HANFORD SITE
BASELINING AND LHST SCHEDULING:
REVIEW/ASSESSMENT/INDEPENDENT VERIFICATION

CRITICAL COMMENTS ON

"REVIEW OF GROUNDWATER TRAVEL TIME ANALYSIS FOR THE REFERENCE
REPOSITORY LOCATION AT THE HANFORD SITE",
Terra Therma/Nuclear Waste Consultants (June 13, 1986)

"RE-REVIEW OF CLIFTON'S-BWIP GROUNDWATER TRAVEL TIME ANALYSIS",
Terra Therma/Nuclear Waste Consultants (January 13, 1987)

PREDICTION OF HYDRAULIC HEAD FIELD USING 30 HEAD AND 20 TRANSMISSIVITY MEASUREMENTS

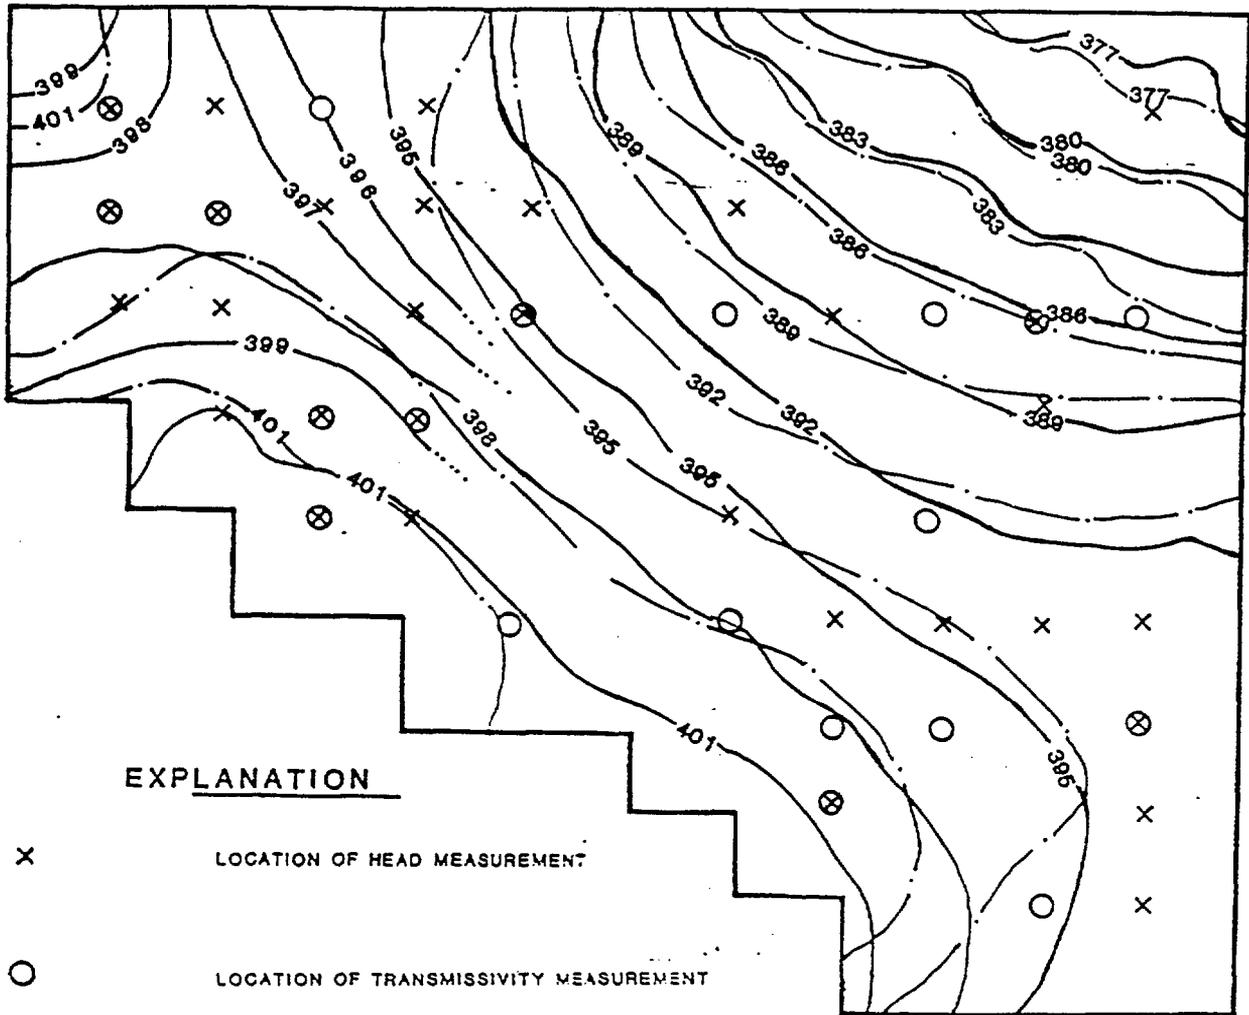
- * AMONG THESE GEOHYDROLOGIC CONDITIONS IS THE
HYDRAULIC HEAD FIELD
- * IS THE PROPOSED MONITORING NETWORK ABLE TO
PROVIDE ADEQUATE PREDICTION OF THE HEAD FIELD?

TO ANSWER THIS QUESTION, WE CONSIDERED THE PRIEST RAPIDS MEMBER

THIS LAYER IS THE ONE THAT HAS THE MOST MONITORING FACILITIES

- (1) WE USED THE STATE-OF-THE-ART SOLUTION OF THE INVERSE PROBLEM TO ESTIMATE THE PARAMETERS DESCRIBING THE SPATIAL VARIABILITY OF THE TRANSMISSIVITY FIELD USING TRANSMISSIVITY AND HEAD MEASUREMENTS
- (2) ONCE THE SPATIAL VARIABILITY HAD BEEN CHARACTERIZED, WE USED THE RECOGNIZED PARAMETERS TO GENERATE HEAD AND TRANSMISSIVITY FIELDS THAT ARE POSSIBLE REALIZATIONS HAVING THE SAME VARIABILITY CHARACTERISTICS AS THE IDENTIFIED FIELD
- (3) WE USED DIFFERENT SETS OF HEAD AND TRANSMISSIVITY MEASUREMENTS RANDOMLY PICKED FROM THE GENERATED FIELD AND RE-ESTIMATED FROM THESE MEASUREMENTS THE PARAMETERS THAT DESCRIBE THE SPATIAL FIELD
- (4) WE COMPARED THE EXPECTED HEAD FIELD PREDICTED FROM THE DIFFERENT SETS OF MEASUREMENTS CONSIDERED AND THE ORIGINAL HEAD FIELD THAT SHOULD HAVE BEEN RETRIEVED

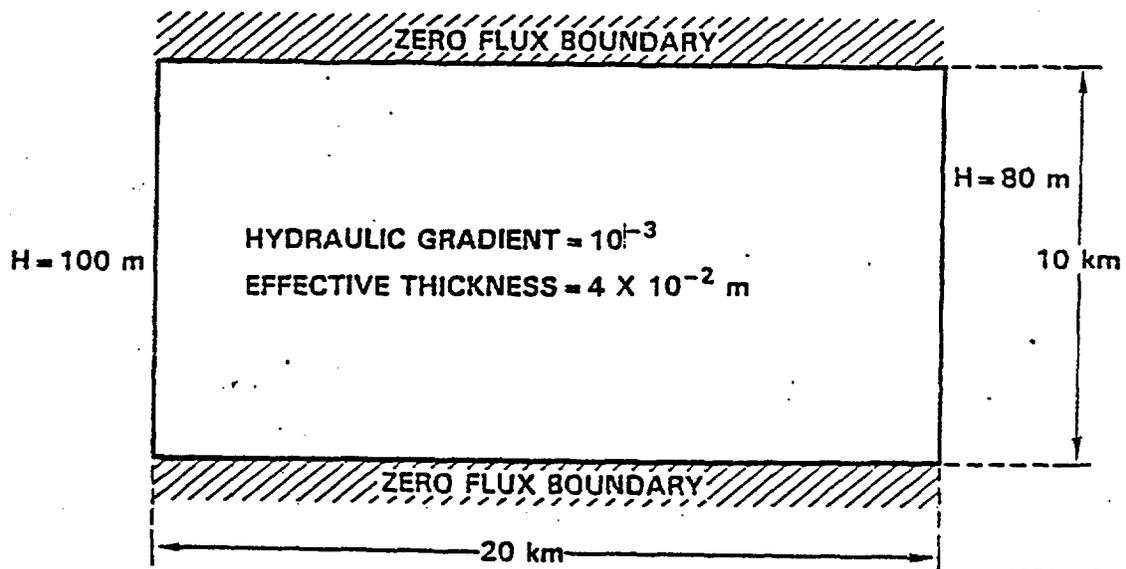
time, simulations may be carried out in an extended domain in which the central zone is spatially variable and its transmissivity is simulated numerically, while the embedding matrix has a constant transmissivity equal to the geometric mean (see Figure 7).

Model Domain and Deterministic Inputs For the Pre-Waste-
Emplacement Stochastic Groundwater Travel Time Analysis

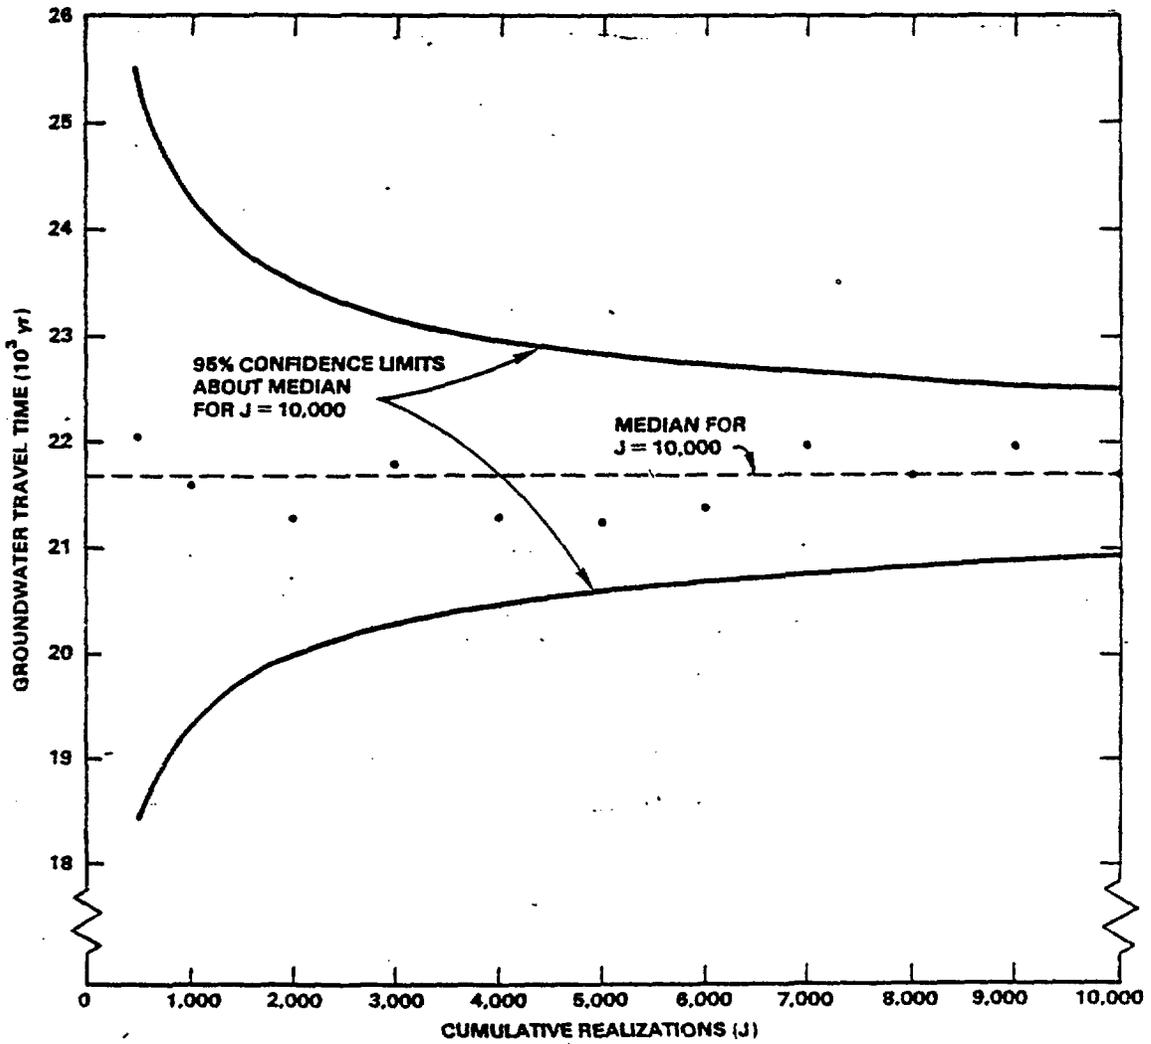
In the Reference Case, the domain under study is a rectangle with dimensions 20 km by 10 km. Impermeable boundary conditions are set along the two longer dimensions. Constant head boundaries are set along the shorter dimensions so that the regional hydraulic head gradient is 10^{-3} . Effective thickness is deterministically set at a uniform value of 0.04 m. Figure 1 shows the flow domain and deterministic input as defined for the Reference

The selection of the flow domain as a rectangle of restricted area bounded by two lines of constant head and two impervious boundaries may lead to different results from those obtained for a larger domain. To save computer

GROUND WATER TRAVEL TIME DISTRIBUTION

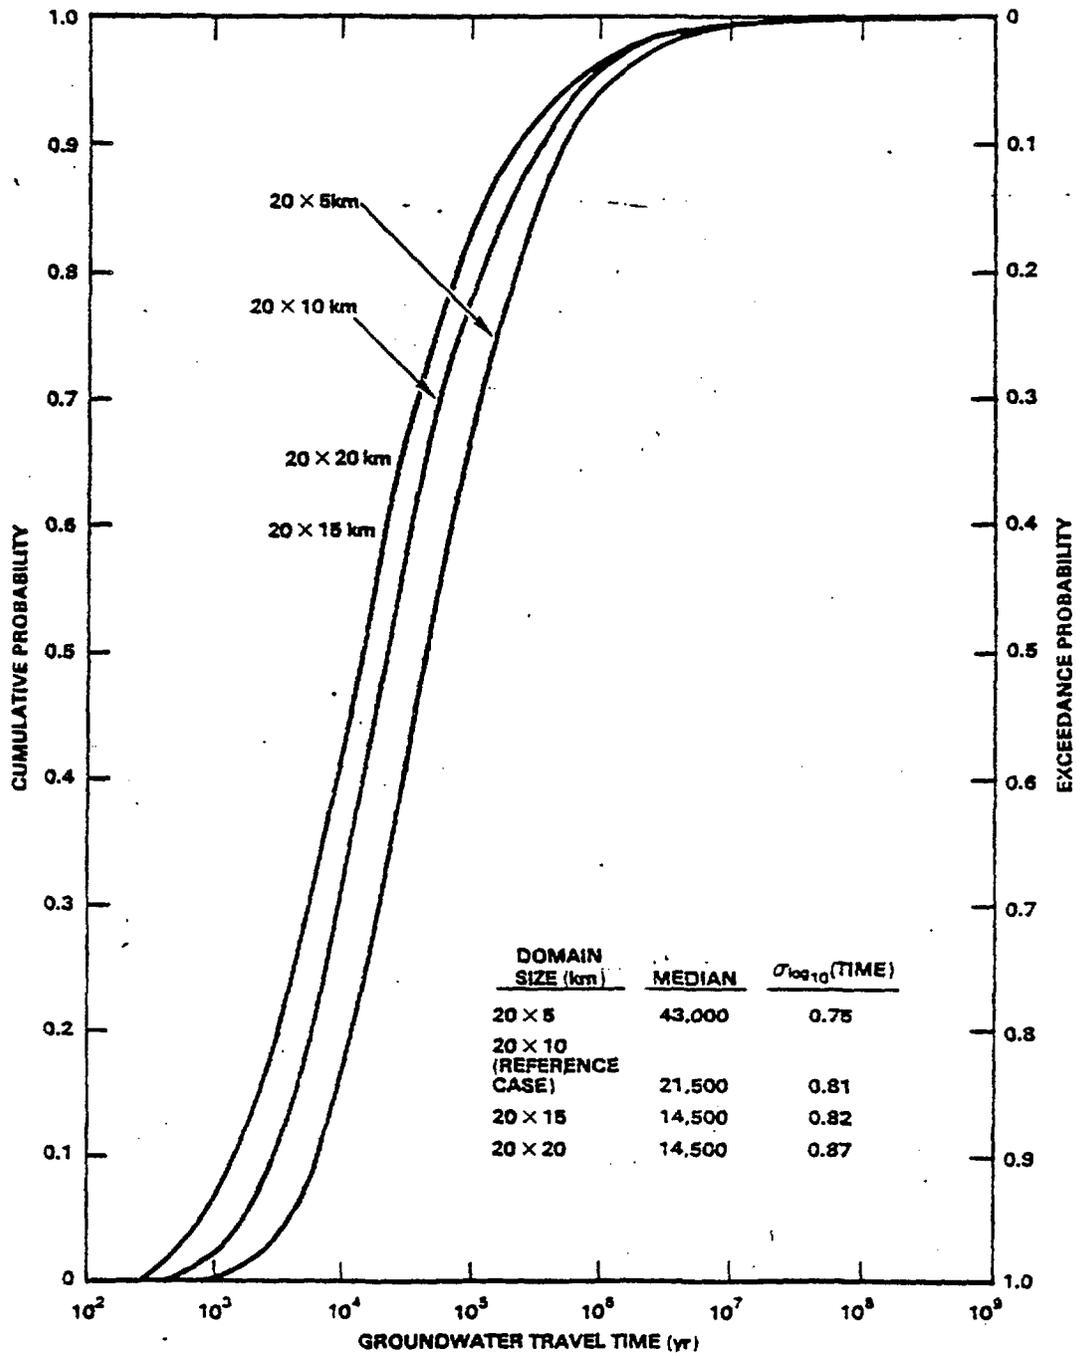
at the tail of the probability distribution. For example, it can be seen from Clifton (1984) (see Figure 2) that the median travel time does not stabilize even after 6,000 simulations. This problem would be more amplified in the tail of the GWTT distribution and a greater number of realizations would be needed to accurately assess the probability exceedance of 1,000 yrs. As a matter of fact, the number of Monte Carlo realizations utilized in order to depict the tail is probably small. As pointed out by Nguyen (1985), presentation of the GWTT probability distribution as a smoothed curve may be imprecise near the tail, which is the zone of interest. The investigators should provide an enlargement graph of the tail of the GWTT empirical distribution derived from the Monte Carlo analysis. A separate assessment of the interval of confidence, similar to that of Figure 2, should be provided for the tail region.
